**Historic Preservation Review Commission**

# **IDAHO SPRINGS HPRC STAFF REPORT**

**Re:** **Proposed Landscape Improvements at the Carnegie Library, 219 14<sup>th</sup> Street**

# **Idaho Springs Public Library – Site Improvement Plan**

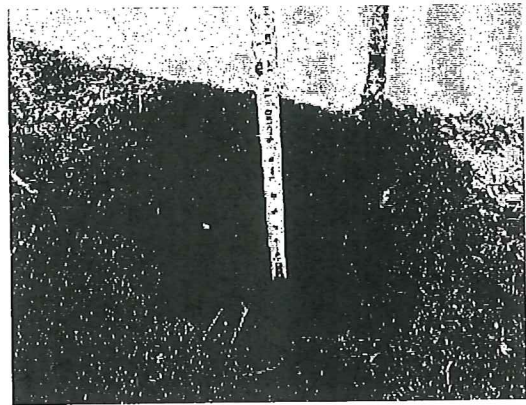
1. Retain existing grade at base of building due to location of stone water table, which also functions as basement window sills. Address drainage at SE corner of library. Existing grade on the site has risen over time as evidenced by comparison of the historic photo of the cannon's concrete pad with a current photo of the pad.

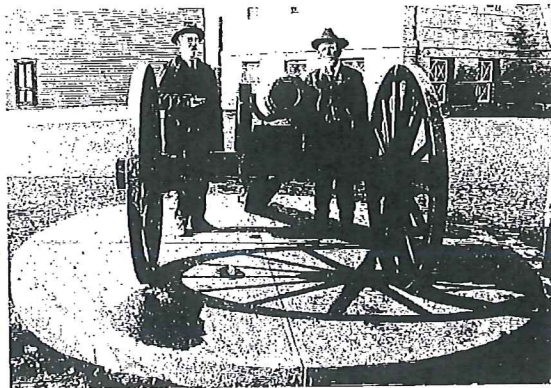
2. We need to determine, if possible, whether the cannon's concrete base was replaced and moved in the past. The SHF prefers that we leave the base in its original historic location but would allow the base to be moved a few inches if the base is replaced.

The cannon base appears to be original, based upon comparison of the existing base with historical photos. However, the concrete has deteriorated. The concrete should be repaired, if feasible, or replaced in-kind with identical control joint locations.

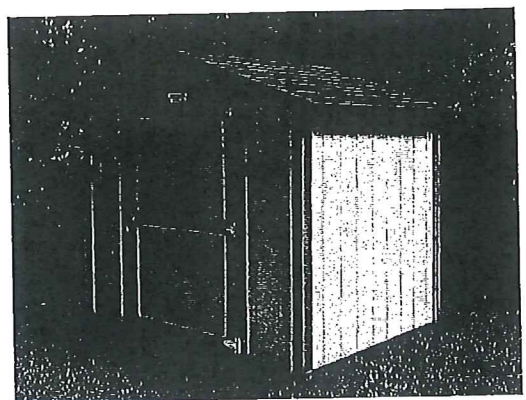
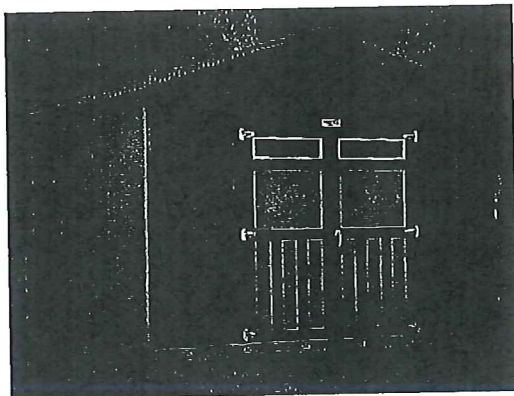
3. The existing south steps to the library's lower level must be retained. A railing on one or both sides should be provided to improve safety. The railing design will need to be approved by the SHF and the City.

The proposed railing is a simple 2" diameter pipe rail, similar to the railing installed at the center of the main entry stairs.

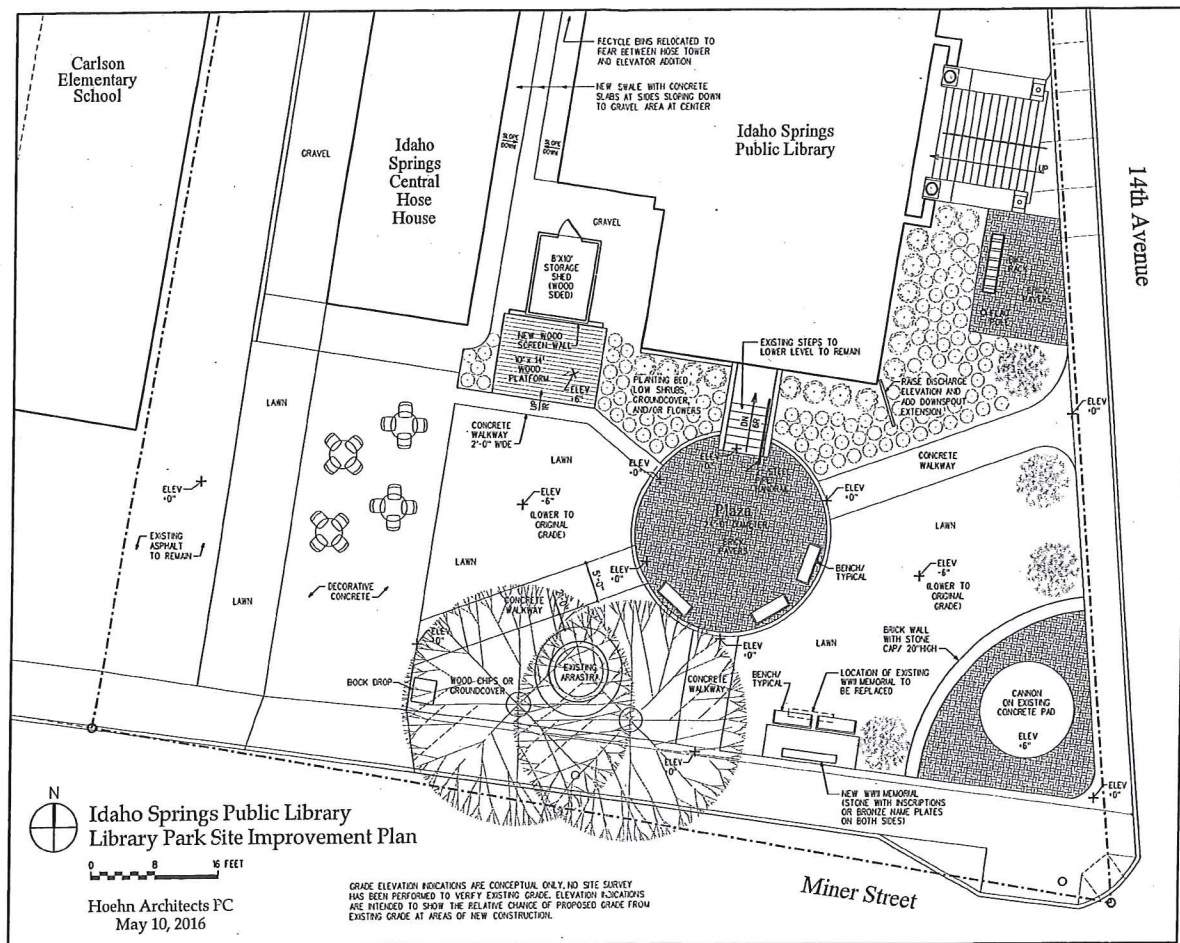
9. The downspout at the southeast corner of the library will be terminated higher than existing with an extension that drains into the adjacent planting bed.

This is shown on the updated drawing.

*Photo of World War II Memorial*

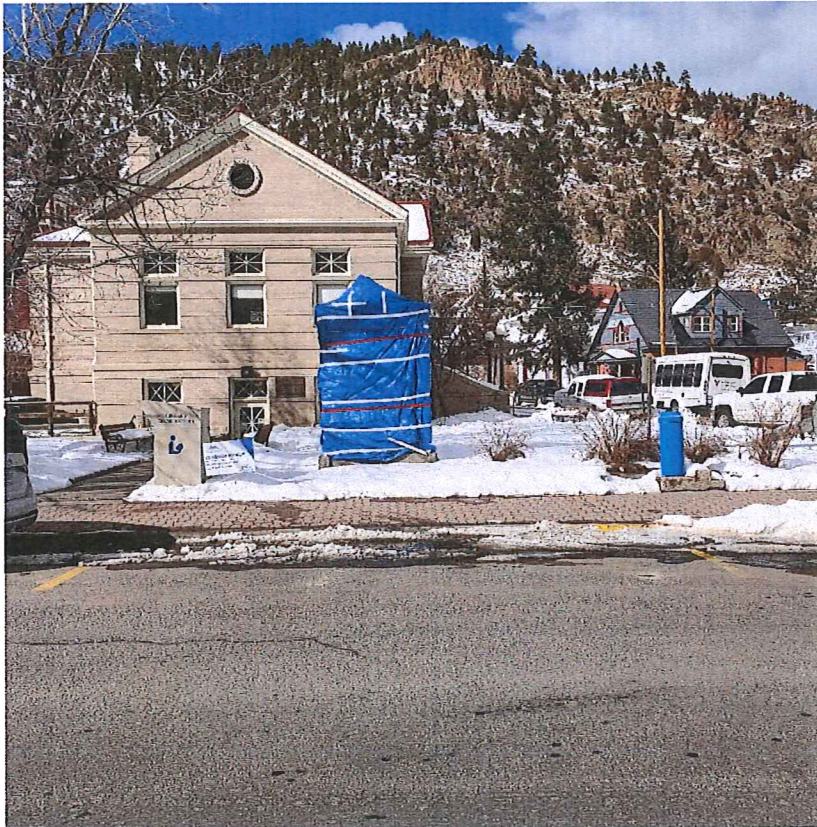
At its March 27 meeting, the Committee discussed in detail the memorial and its eventual design. Previously, the Committee had recommended restoration/reconstruction of the existing memorial. At that time, however, the Committee was not aware of the complete redesign shown in the Landscape Design Plan.

The Committee supports placing the memorial at the revised location as shown on the design plan, regardless of the memorial's design.

Two members are in favor of going with the new design as shown in the landscape plans and two are in favor of reconstructing the old one.
